Detailed Site Plan Highland Park Senior Housing

DSP-91071-03

STAFF REPORT

SUBJECT: Detailed Site Plan DSP-91071-03
Type 2 Tree Conservation Plan TCP2-016-2023
Highland Park Senior Housing

Figure 2: West Elevation

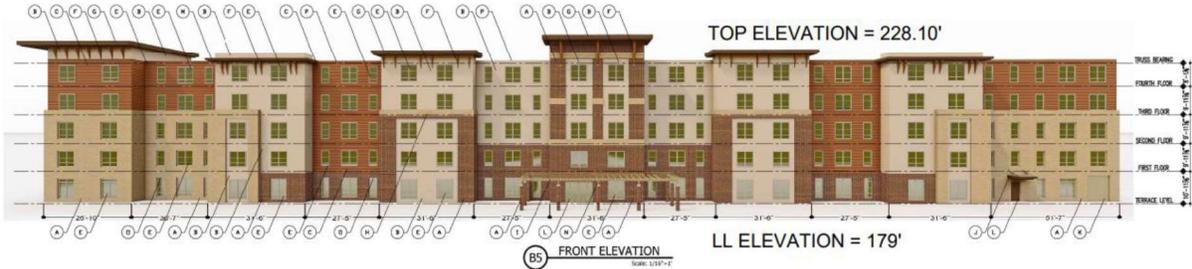
Access to the utility service room will be located around the north end of the building. However, the provided west elevation does not show this access. A condition is included herein requiring the applicant to revise this technical error on the certified DSP.

3. Prior to certification, the applicant shall revise the architectural plans and elevations, as follows:
 - a. Revise the west elevation of the building to reflect access to the utility service room located at the north end of the building.

LANDSCAPE PLAN

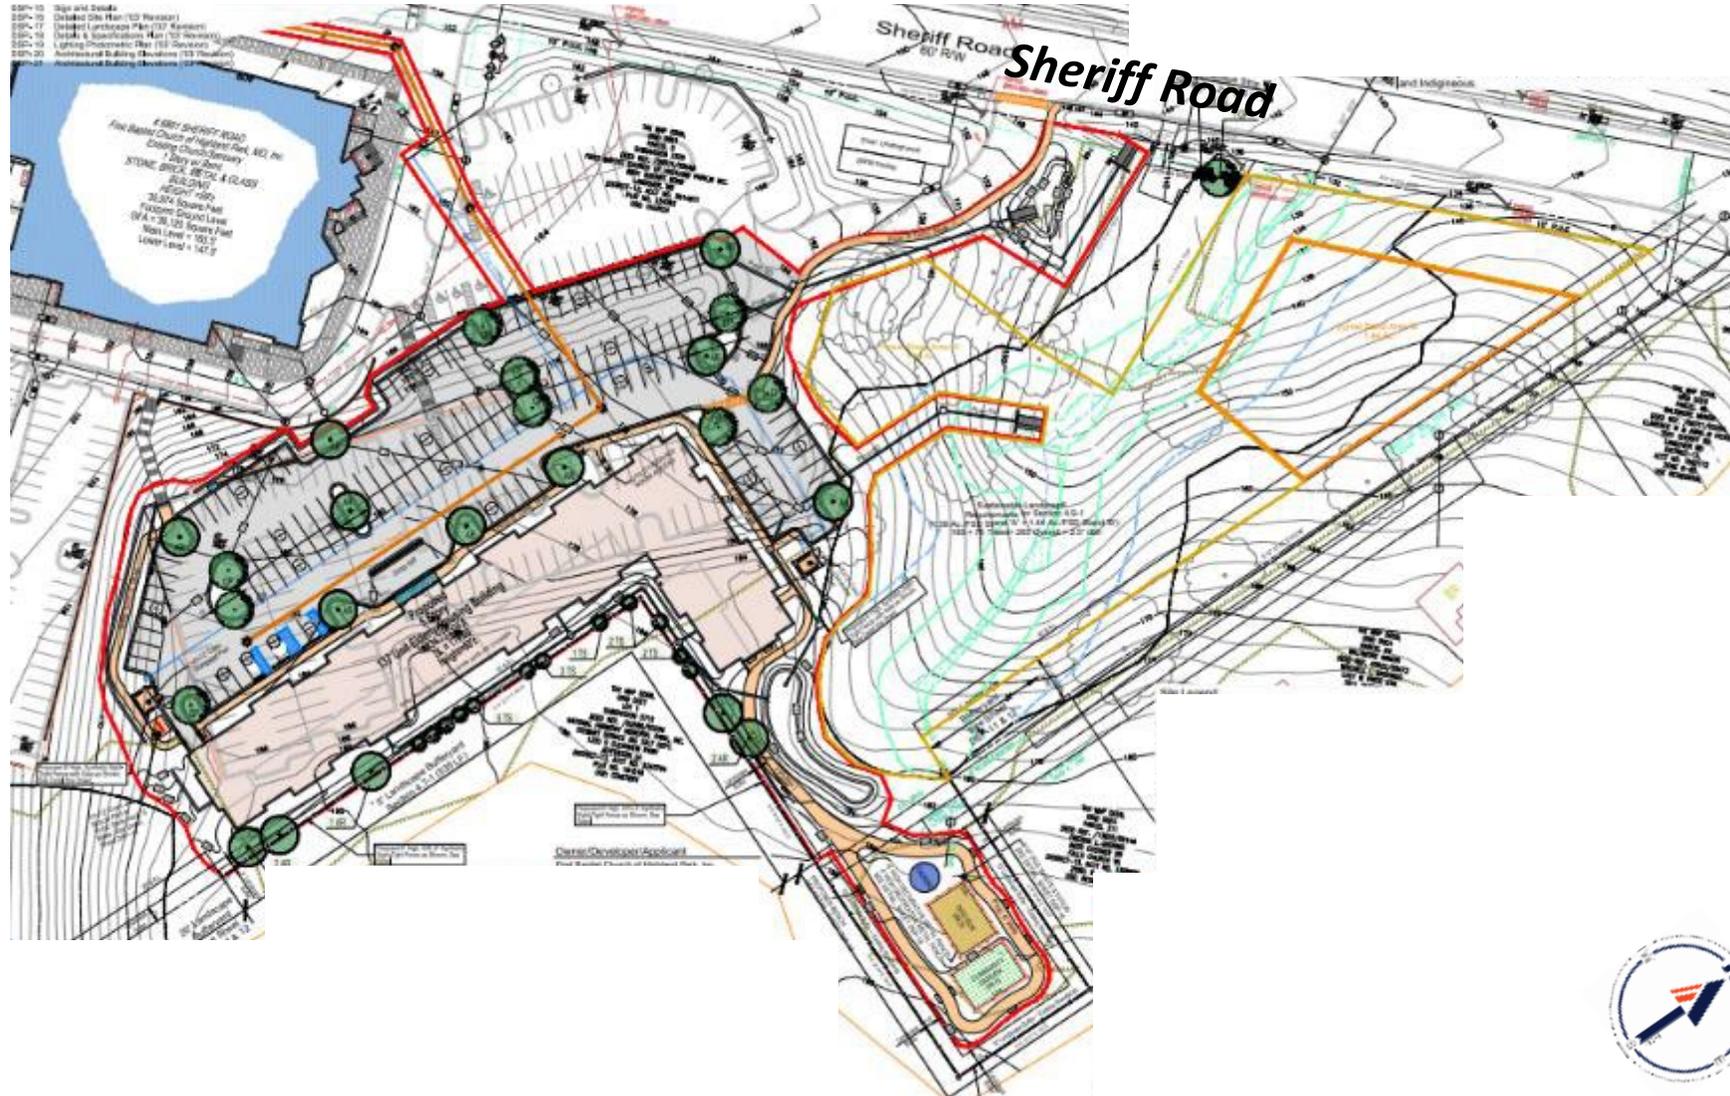
Sheet DSP-17, Schedule 4.1-4 Residential Requirements for Multifamily, shows the green space provided for the subject site is 175,000 square feet. The applicant should clarify how this square footage is determined since the coversheet (Sheet DSP-1) indicates that the green area provided for the entire parcel is 490,063 square feet. A condition is included herein requiring the applicant to confirm the green area provided.

Schedule 4.1-4 on Sheet DSP-17 indicates 265 existing shade trees, which is less than the required 287 trees. Conditions have been included herein requiring the applicant to revise the landscape plan with a certificate of landscape maintenance to determine the conformance of the previously approved landscape plan. This certificate can also show the condition of the existing woodlands for the 10-foot landscape buffer around the area for the outdoor recreational facilities on Sheet DSP-17 and determine if additional landscaping is required.

- a. Confirm the green area provided on the subject property.
 - b. Revise the landscape plan to meet the requirements of Section 4.1 of the 2010 *Prince George's County Landscape Manual*, for the entirety of the green area on the subject property.

- c. Provide a certificate of landscape maintenance on the landscape plan for the entire subject property, to ensure the existing landscaping is in compliance with the previously approved landscape plans. If plants are missing, they must be shown as proposed with this landscape plan.

- d. Per Section 4.2(c)(3)(ii) of the 2010 *Prince George's County Landscape Manual*, one shade tree and five shrubs shall be provided for every 35 linear feet of frontage. Add one additional shade tree to Schedule 4.2-1 and label it on the plan.

- e. Revise Schedule 4.3-2, regarding the provision of a planting island and square footage of the parking area.
 - f. On Sheet DSP-17, revise "Sustainable Landscape Requirements for Section 4.9-1" to "Residential Requirements for Multifamily for Section 4.1-4."

PROPOSED RECREATIONAL FACILITIES

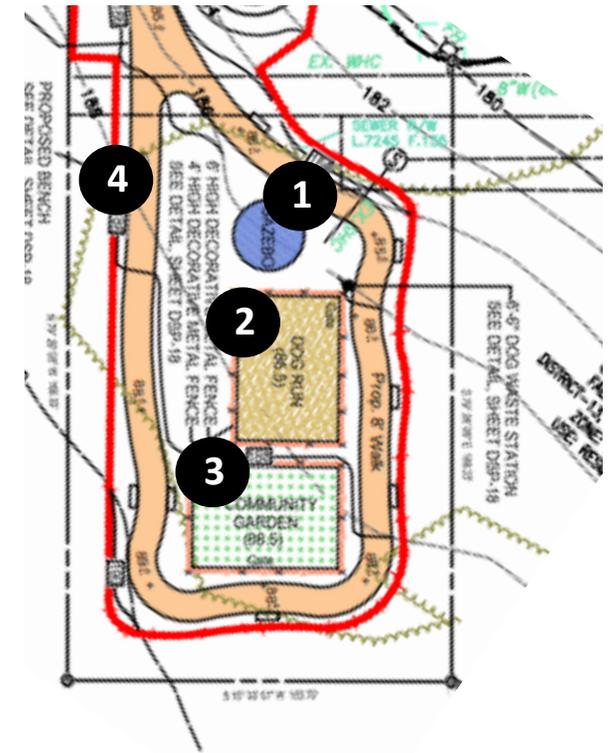
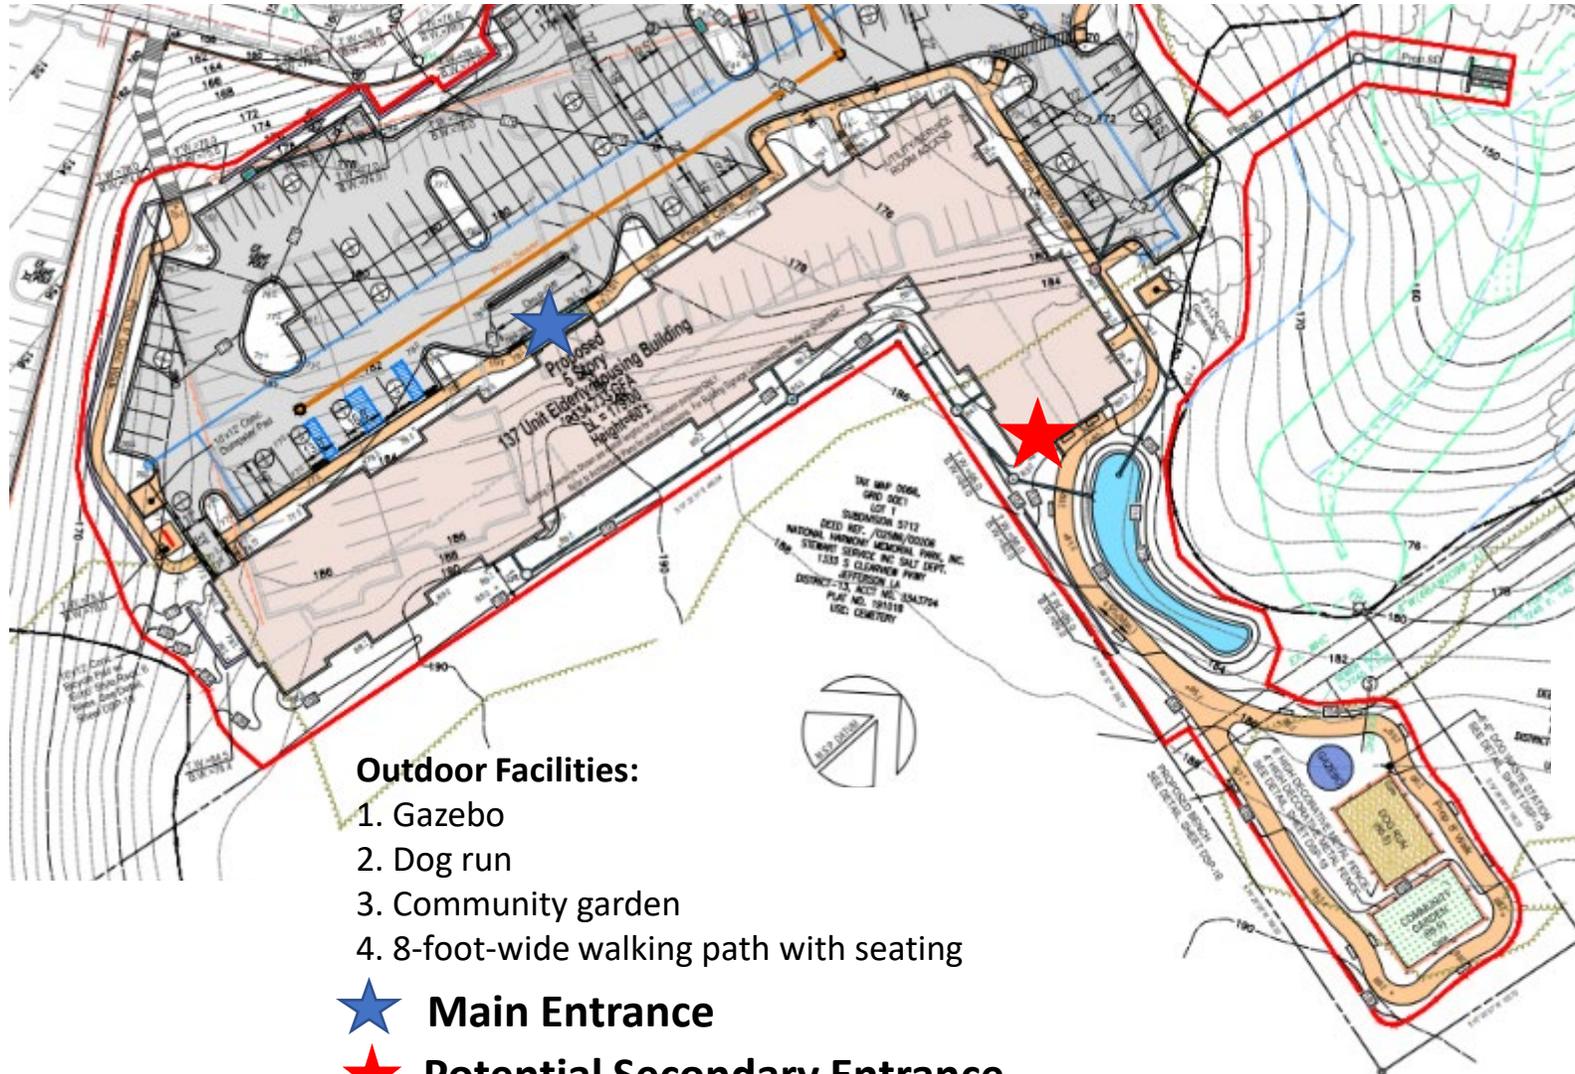
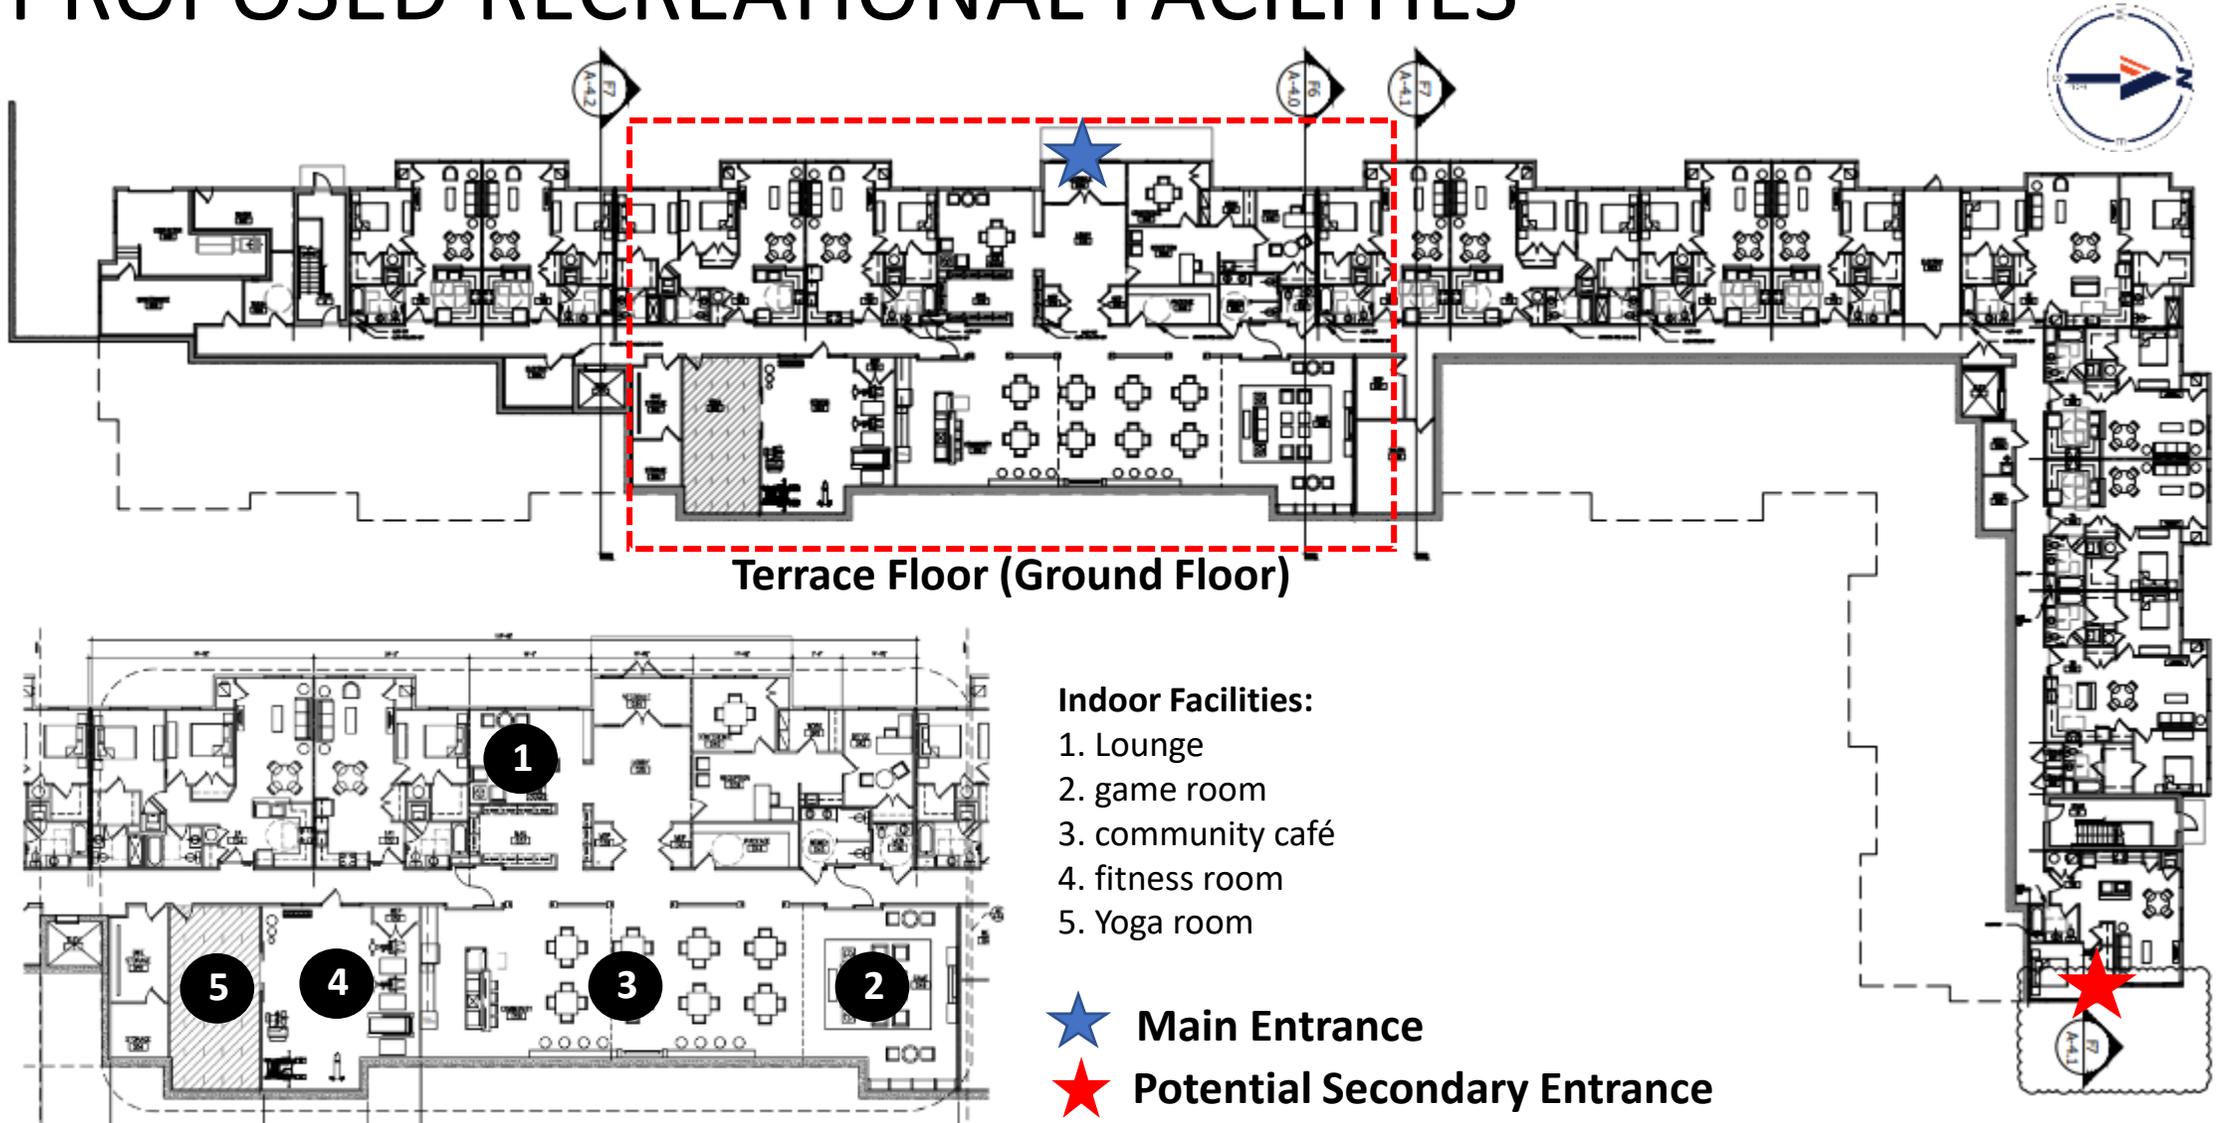
On Sheet DSP-17, the 8-foot-wide walking path encloses three outdoor recreational facilities: a gazabo, a dog run and a community garden. However, the plan does not show the connection between these facilities and the walking path in order for future senior residents to access them. Some details regarding the dog run and the community garden are also missing, such as dimensions and size, gate details, the type of planting area that will be operated in the community garden (e.g., on the ground or in raised beds), and any structures located within. The applicant also does not indicate the type and quantity of

- (6) Provide a large-scale plan of the outdoor recreational area that clearly shows the connection between the walking path and the gazebo, the dog run, and the community garden, and its material and dimensions.

- (7) Details regarding the gazebo, the dog run, and the community garden shall be added to the plans, such as dimensions and size, gate details, if the vegetable planting area in the community garden would be raised-bed or in-ground, and any structures proposed to be installed within.

- (8) Seating shall be installed within the gazebo. Add seating details to the plans and its value to the amenity list on the coversheet (DSP-1).
- g. Construct a secondary building entrance at the east end of the building, closest to the outdoor recreational area.
